**ADDENDUM NO. 3**

IRONDALE FIRE STATION No. 3

THIS ADDENDUM FORMS A PART OF THE CONTRACT DOCUMENTS. THE FOLLOWING CONDITIONS TAKE PRECEDENCE OVER ANY CONFLICTING CONDITIONS IN THE DRAWINGS AND SPECIFICATIONS. THE DRAWINGS AND SPECIFICATIONS ARE HEREBY AMENDED IN THE FOLLOWING PARTICULARS.

**CWA**  
 SHEET TITLE: SITE LAYOUT PLAN  
 PROJECT NUMBER: CWA No. 2023-01  
 DATE: 8/30/24  
 DRAWN BY: WCV  
 CHECKED BY: CIE  
 SHEET NUMBER: **C1.0**

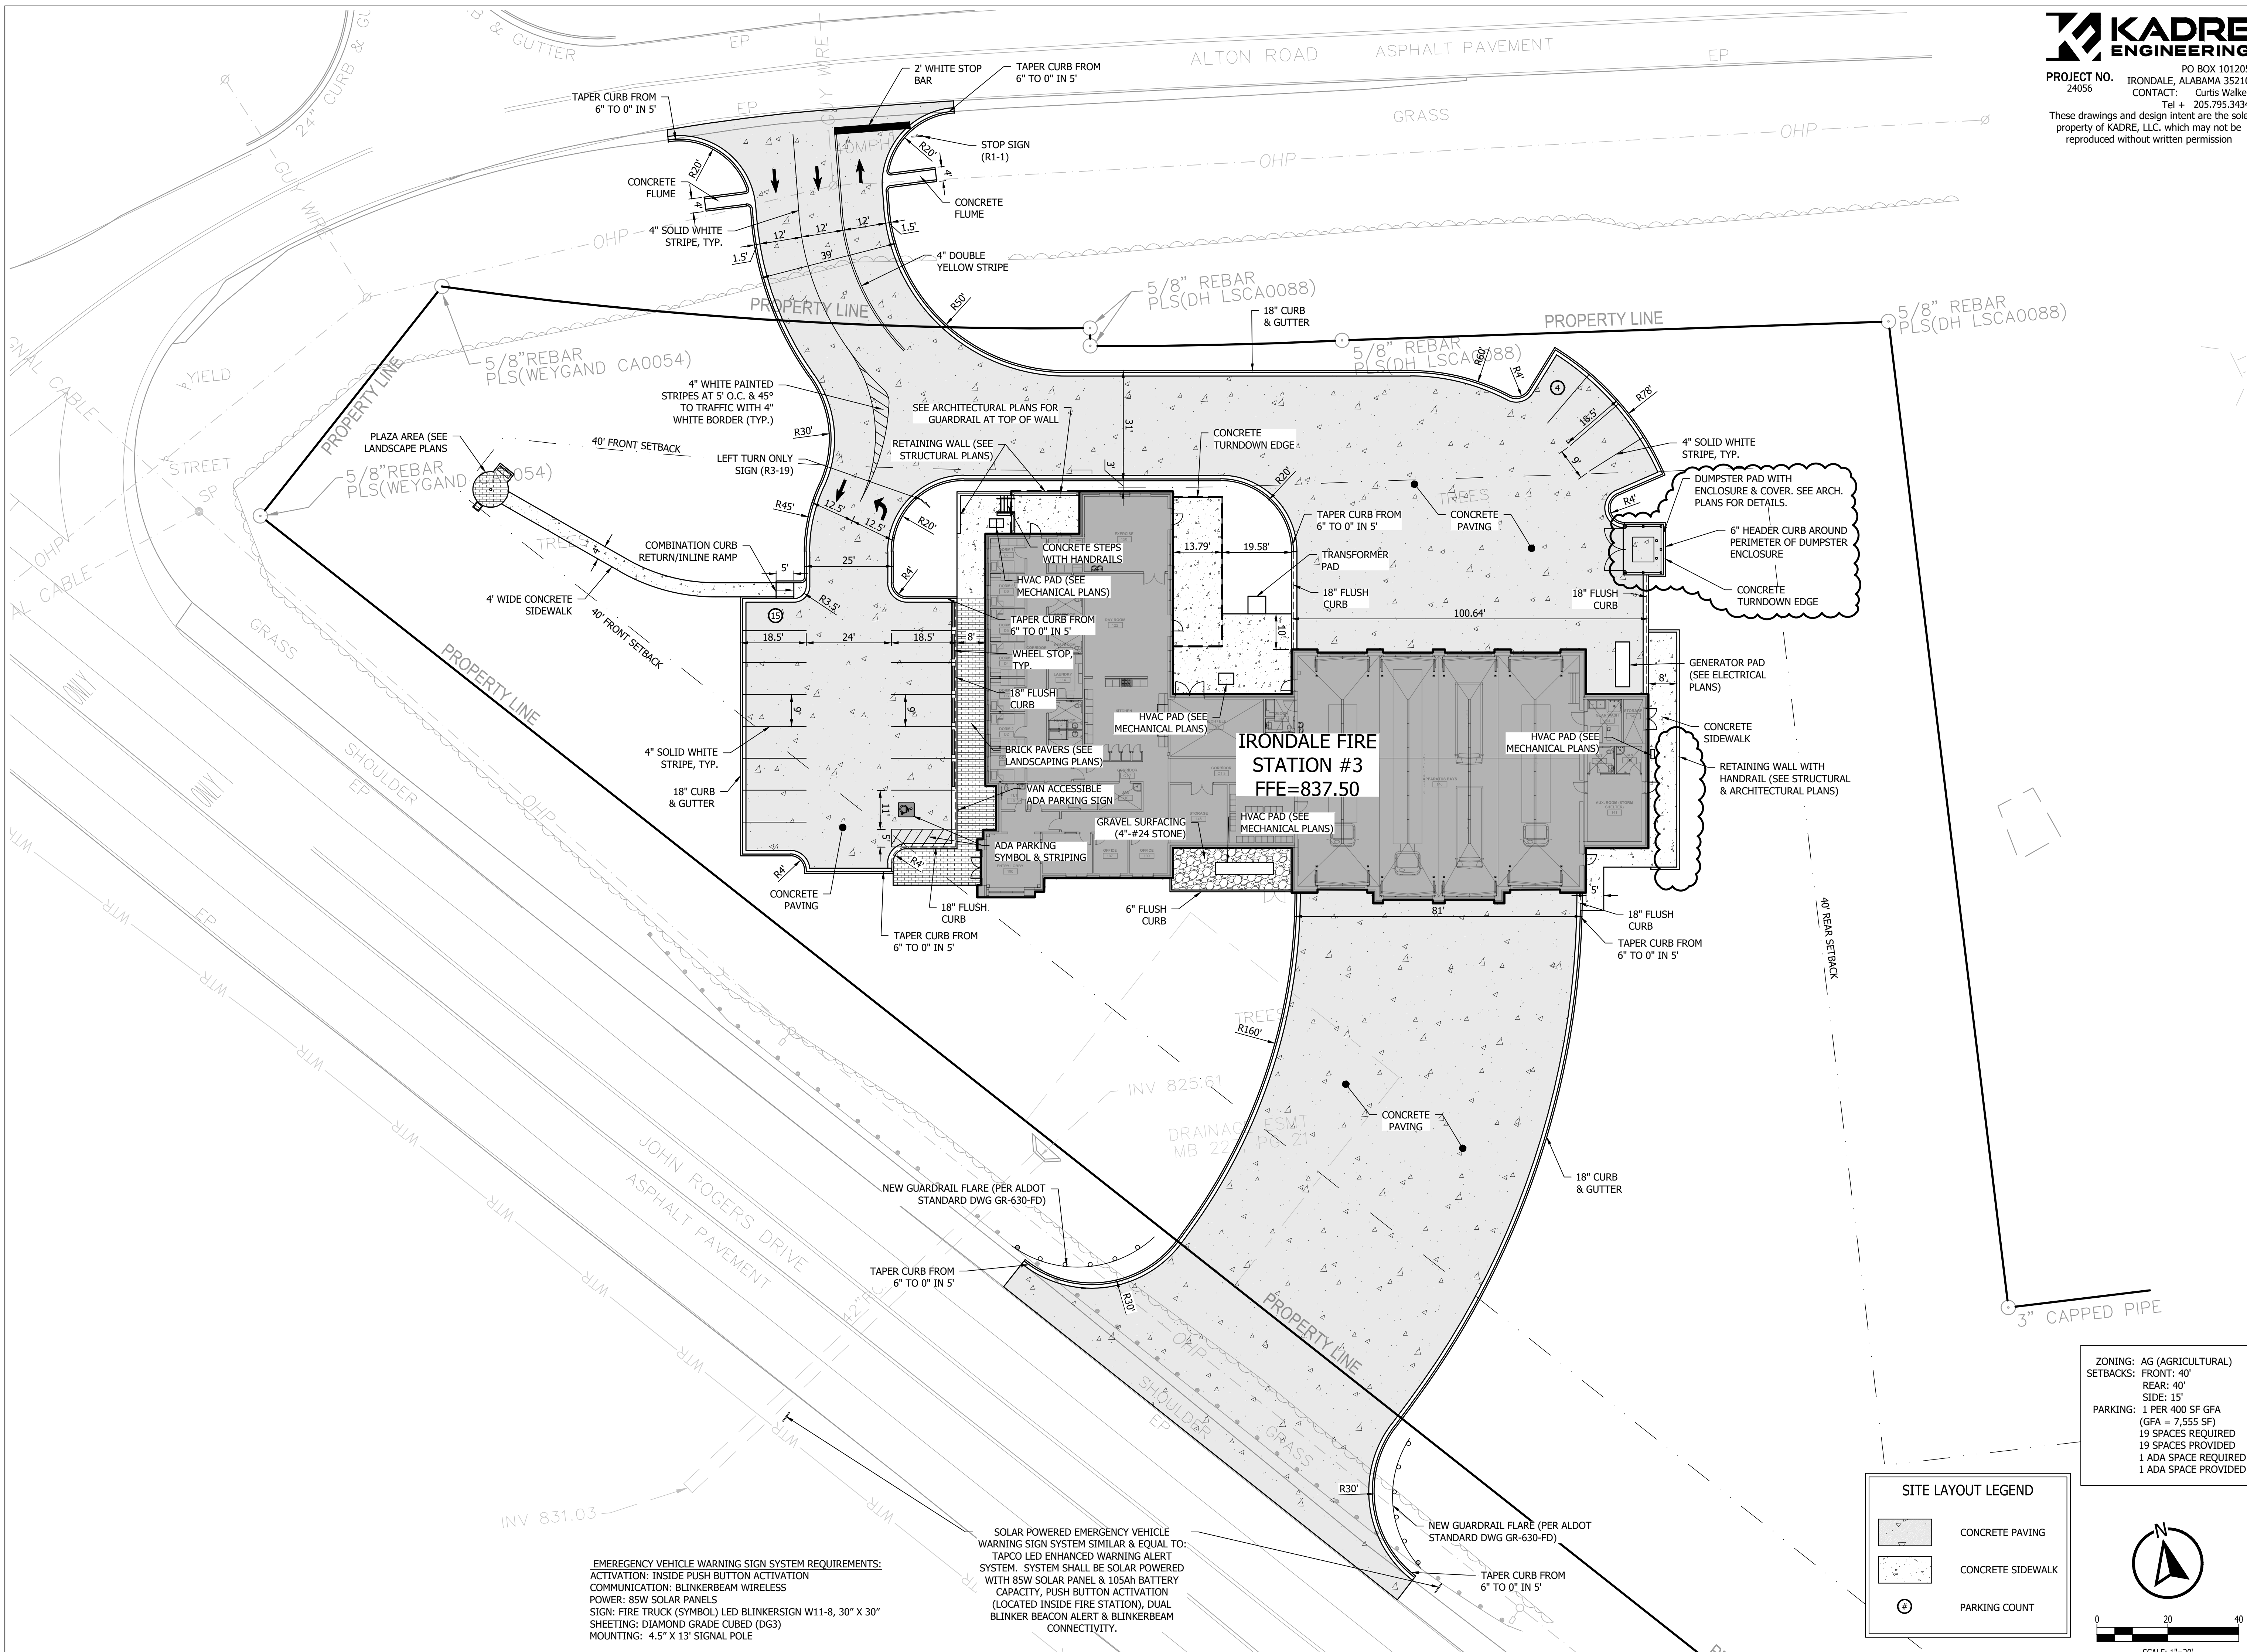
1. C1.0 Site Layout Plan:
  - a. Modified sidewalk and retaining wall near east side of building
  - b. Added 6" curb and turndown edge dumpster enclosure

SHEET TITLE: **SITE GRADING PLAN**  
 PROJECT NUMBER: **CWA No. 2023-01**  
 DATE: **8/30/24**  
 DRAWN BY: **WCW** CHECKED BY: **CIE**  
 SHEET NUMBER: **C2.0**

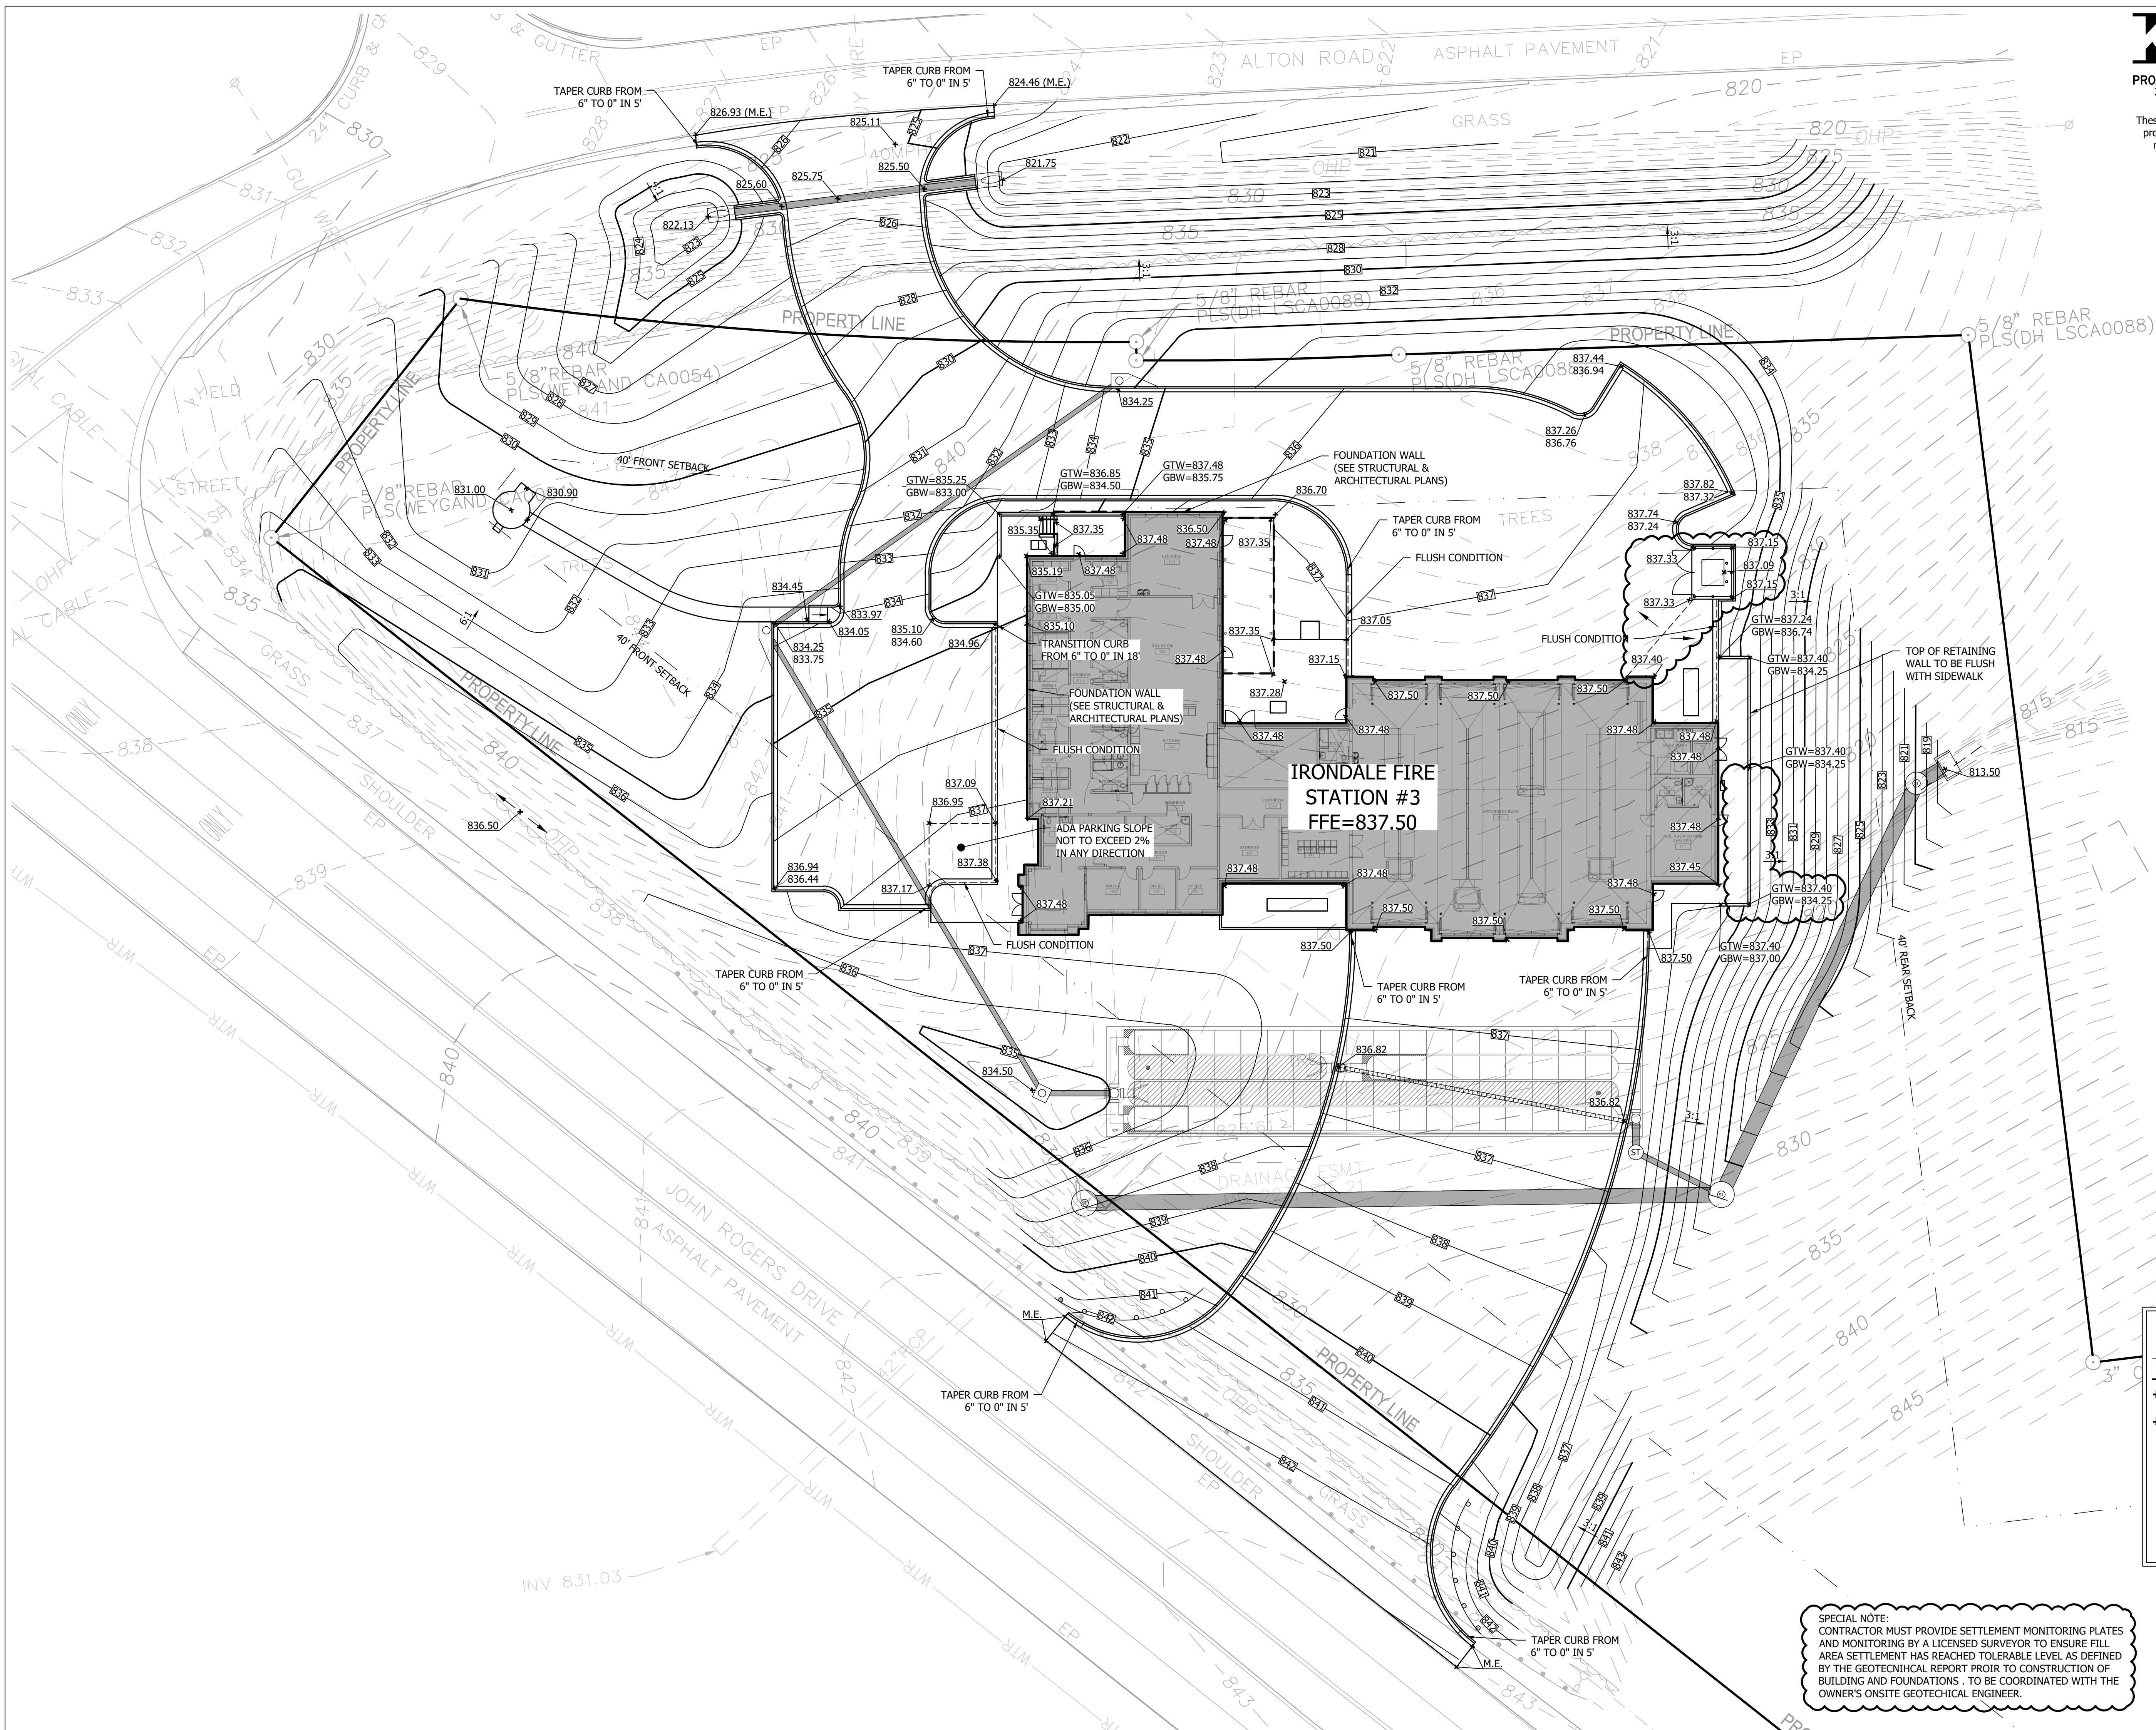
2. C2.0 Site Grading Plan:
  - a. Updated retaining wall grades near east side of building
  - b. Updated spot elevations near dumpster enclosure
  - c. Added note regarding settlement monitoring

SHEET TITLE: SITE DRAINAGE PLAN  
 PROJECT NUMBER: CWA No. 2023-01  
 DATE: 8/30/24  
 DRAWN BY: WCV CHECKED BY: CIE  
 SHEET NUMBER: **C2.1**

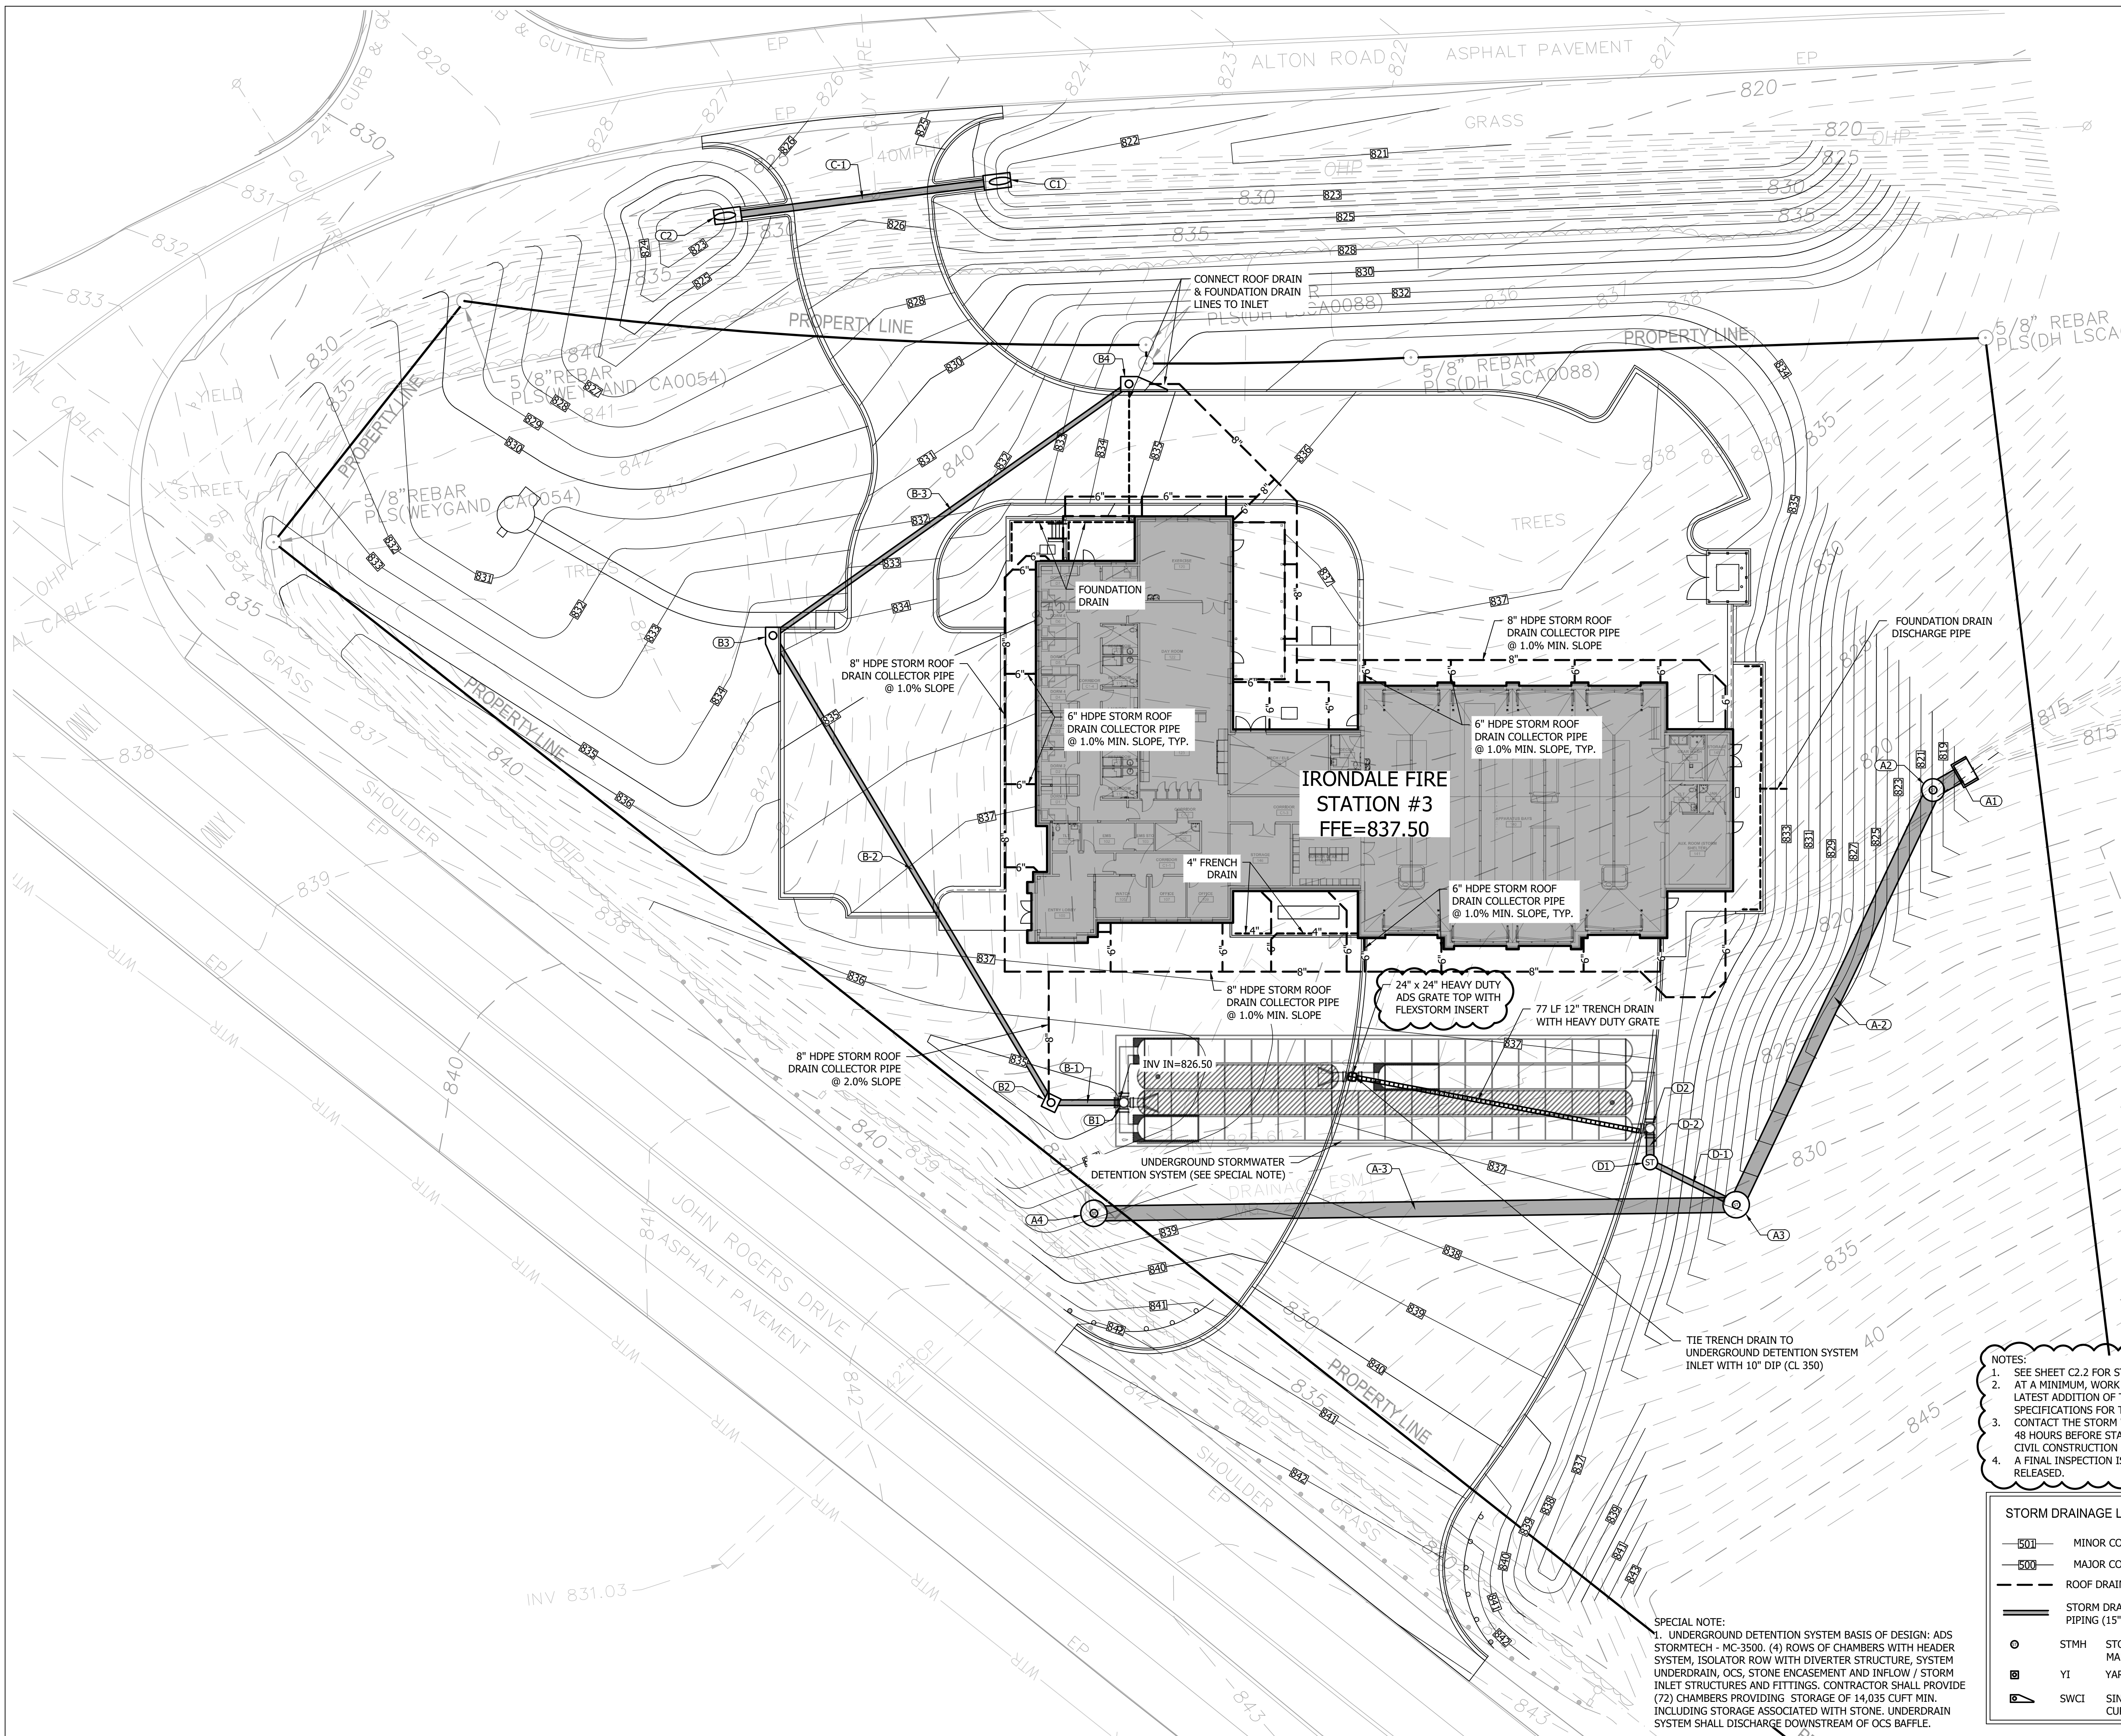
3. C2.1 Site Drainage Plan: Added dumpster floor drain and 4" sanitary line to septic tank
4. C3.0 Site Utility Plan:
  - a. Added Flexstorm Insert to grate inlet connected to underground detention system
